Title & Document Type: HP 339A Operating and Service Manual

Manual Part Number: 00339-90001

MODEL 339A

DISTORTION MEASUREMENT SET

Figure 8-15. Error Detector Circuits.
8-17

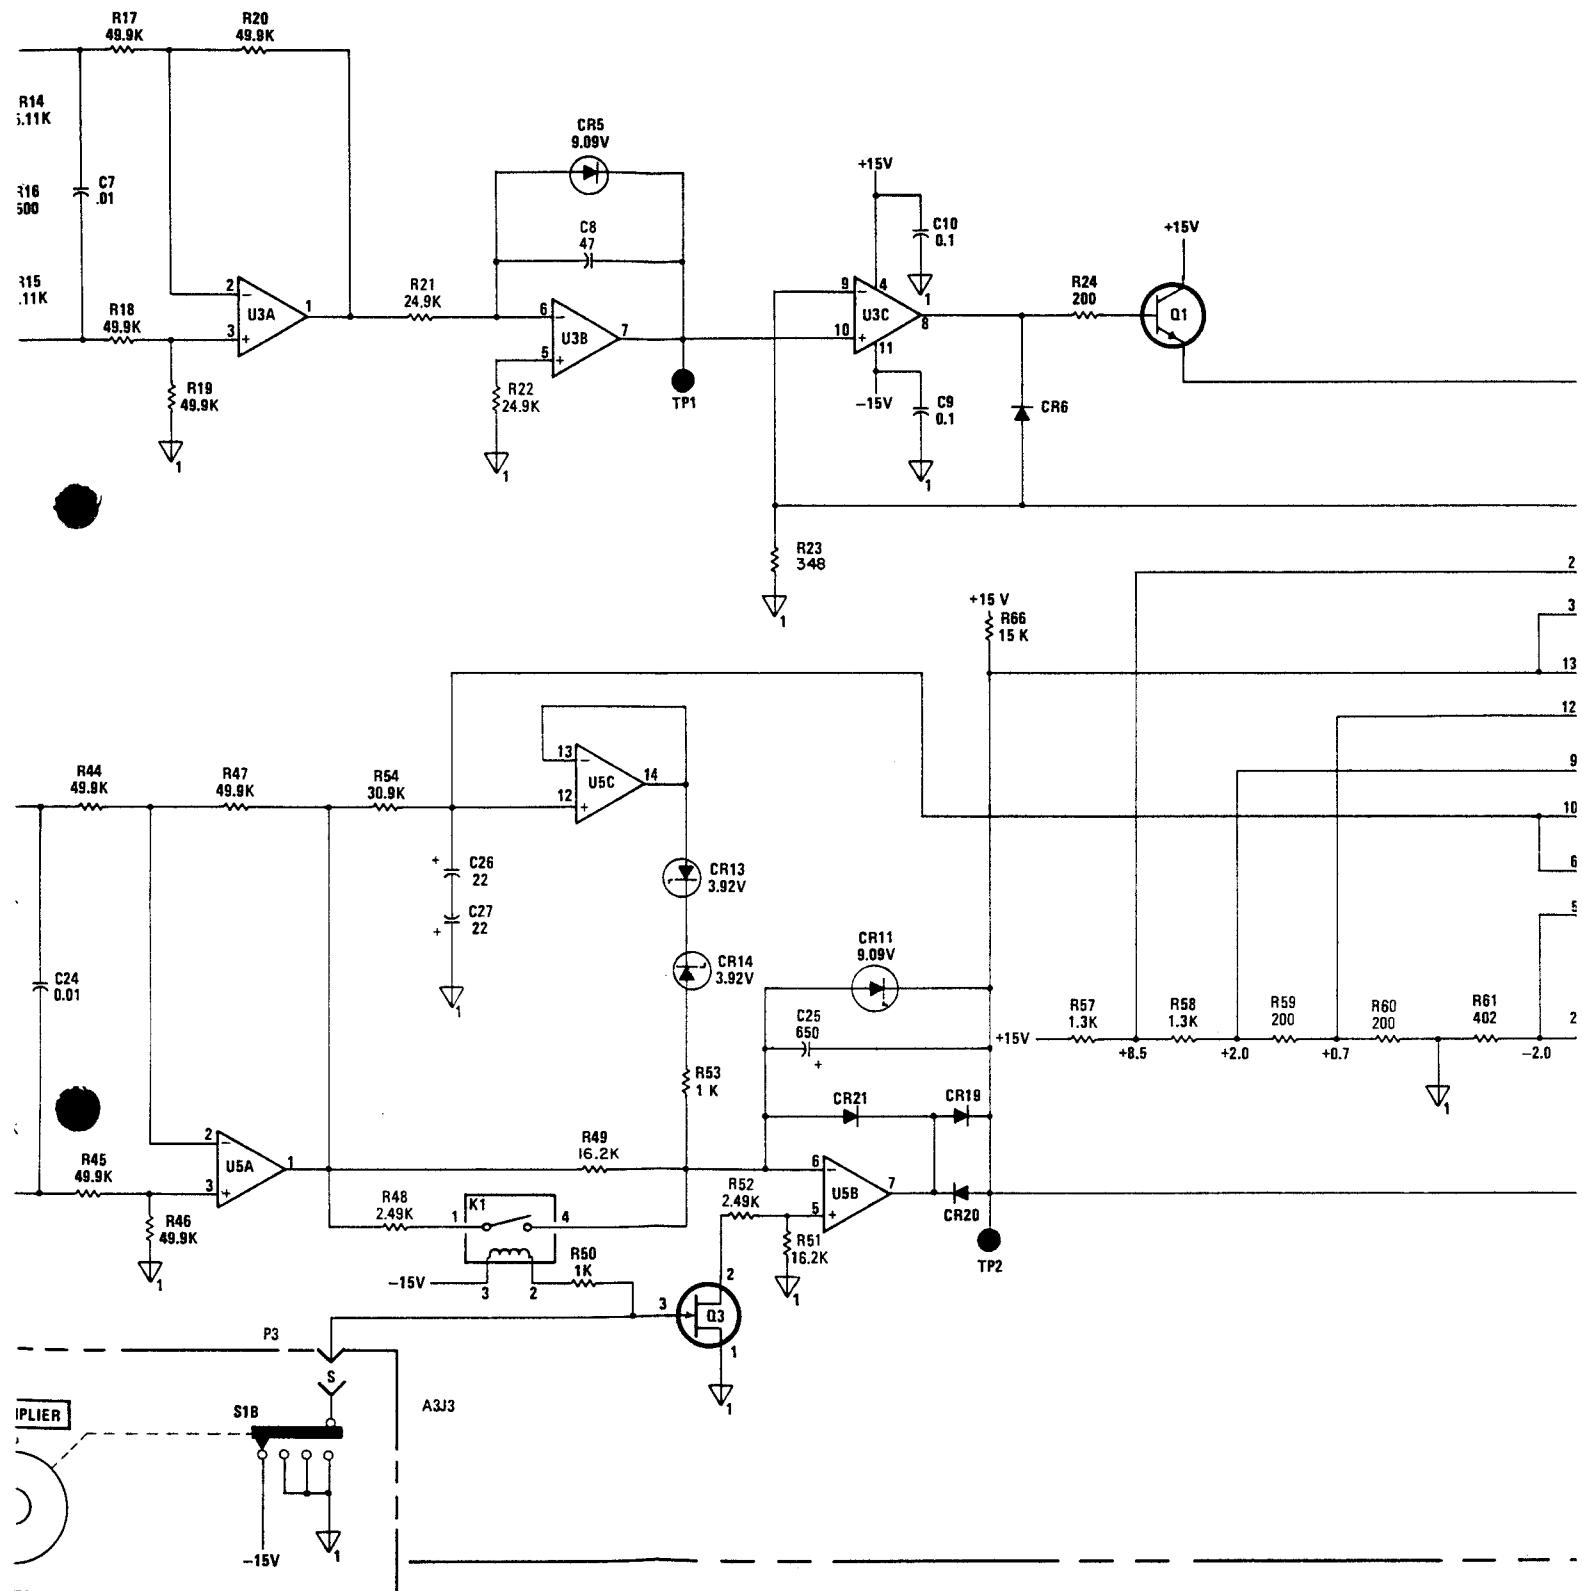
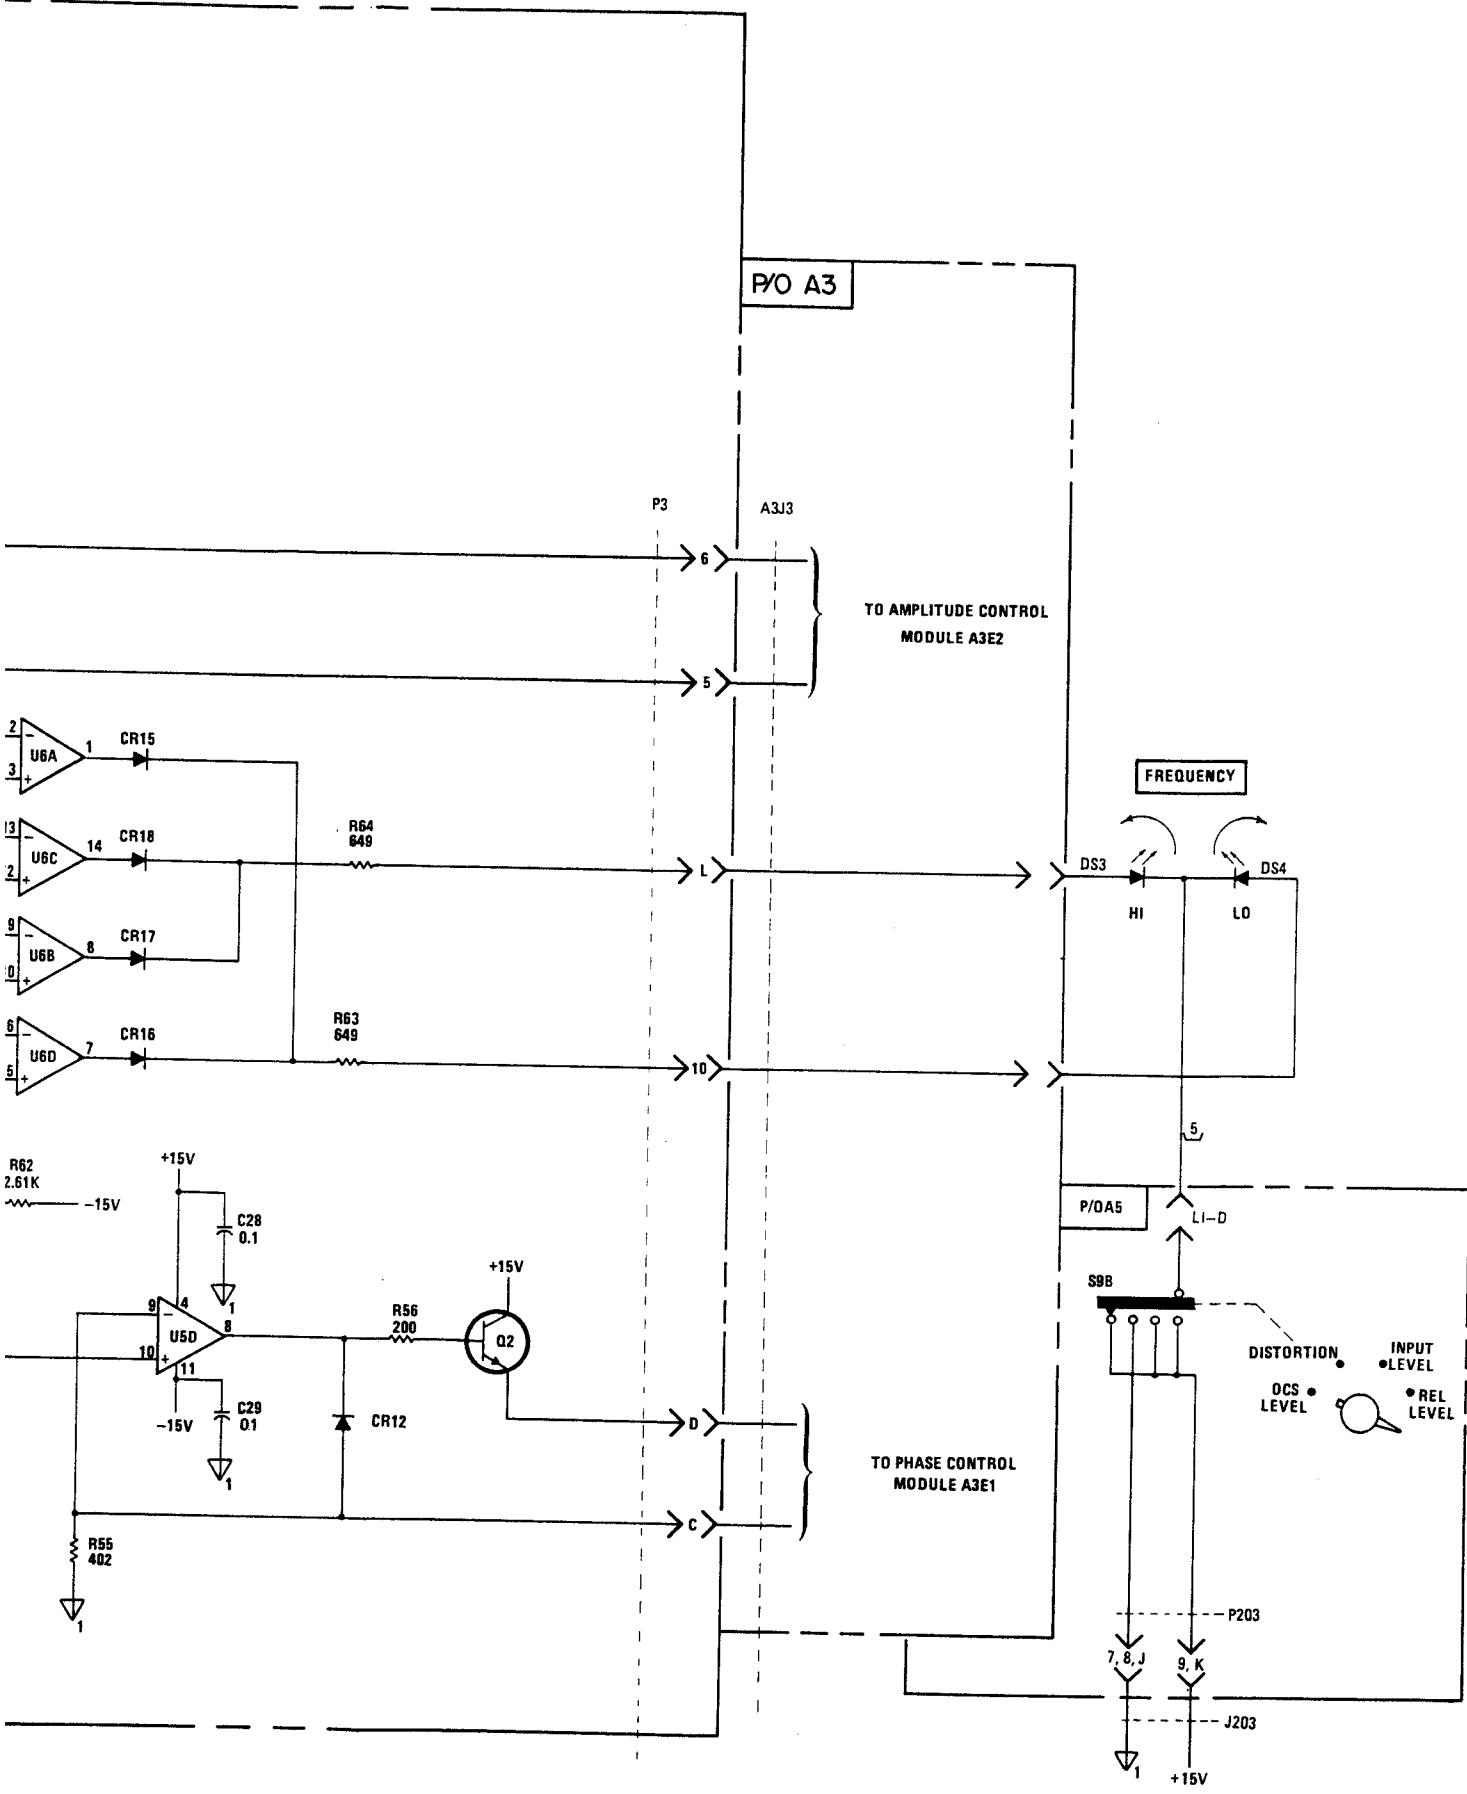
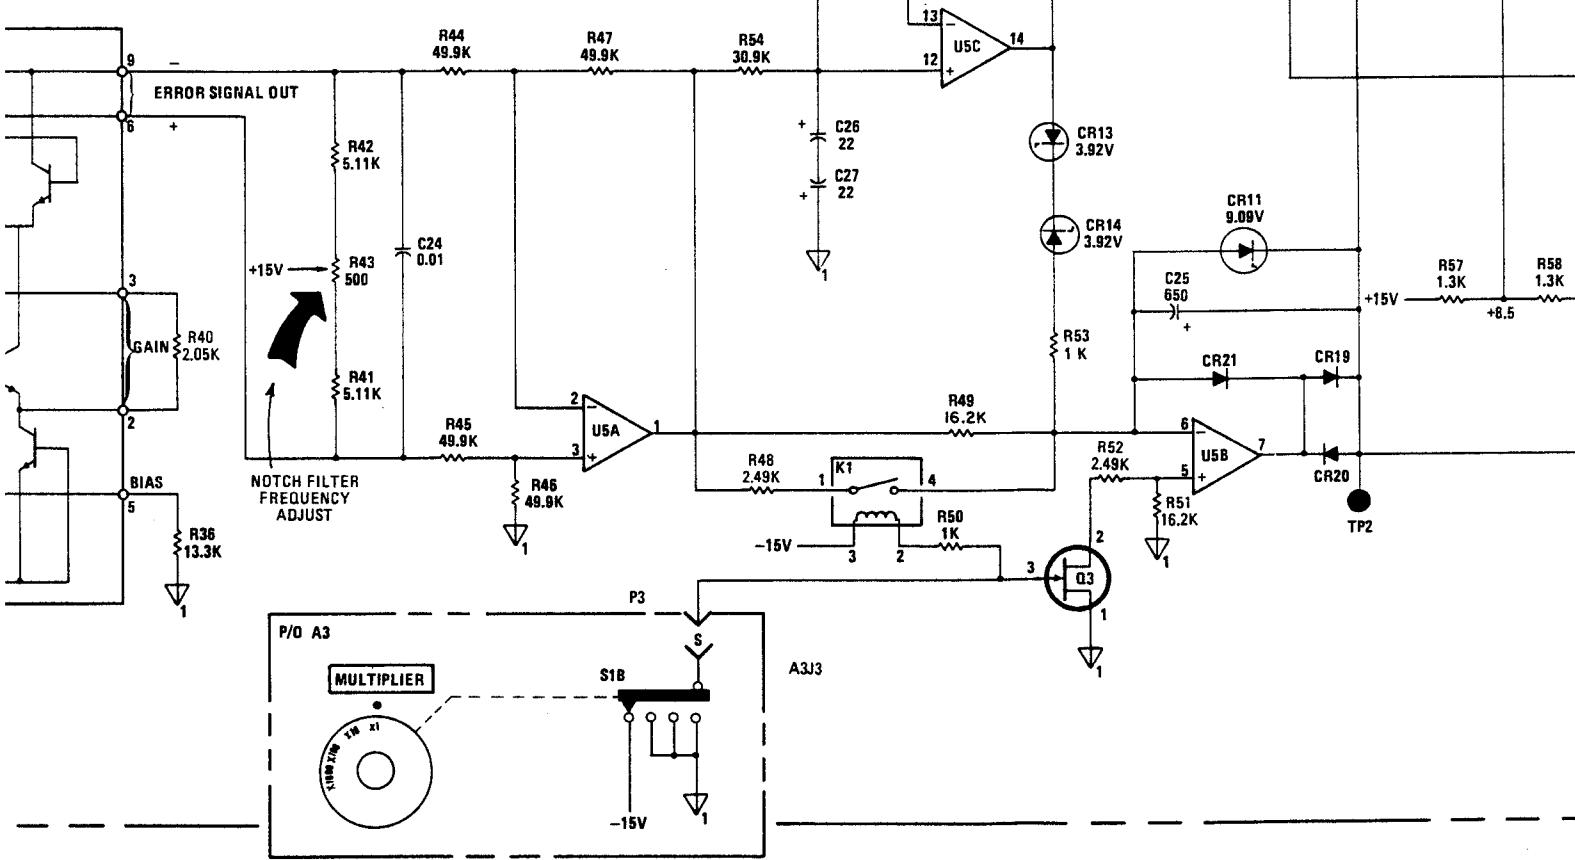
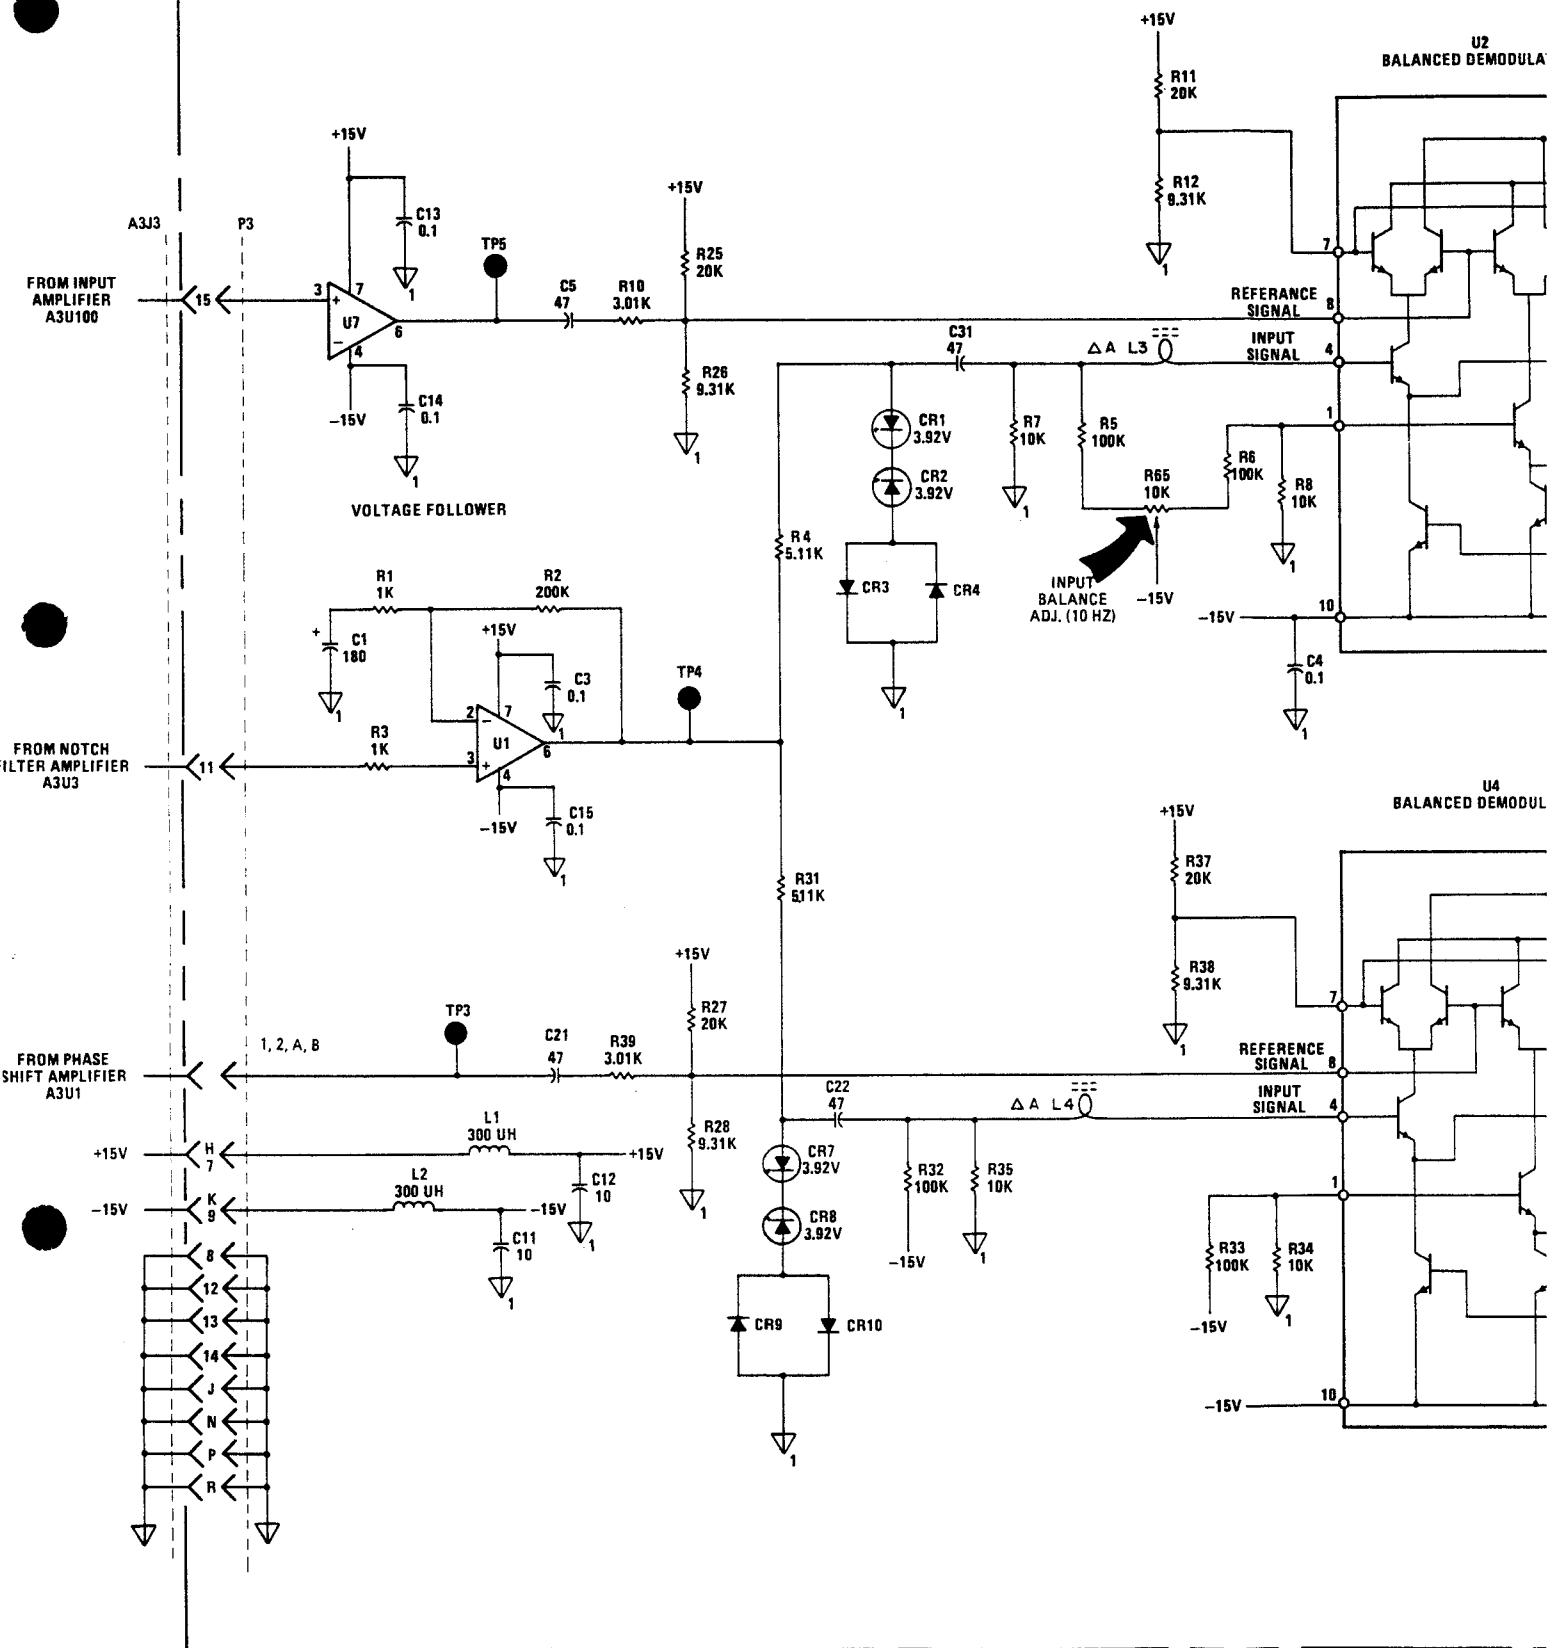
Page 8-17, Figure 8-15. Change the value of R23 from 348 Ω to 324 Ω and the value of R55 from 402 Ω to 348 Ω on the schematic diagram.

Page 8-17, Figure 8-15. Change the schematic value of R59 from 200 Ω to 301 Ω and the value of R60 from 200 Ω to 100 Ω . Change the voltage level at the junction of R59 and R60 from +0.7 to +0.5 volts.

Page 8-17, Figure 8-15. Add capacitor C32* in parallel with R2. The value of C32* should be listed as 5.1pF.

Page 8-17, Figure 8-15. Change the schematic values of R48 and R52 from 2.49kΩ to 5.9kΩ.

Page 8-17, Figure 8-15. Change the value of R2 (feedback on U1) from 200k to 158k.
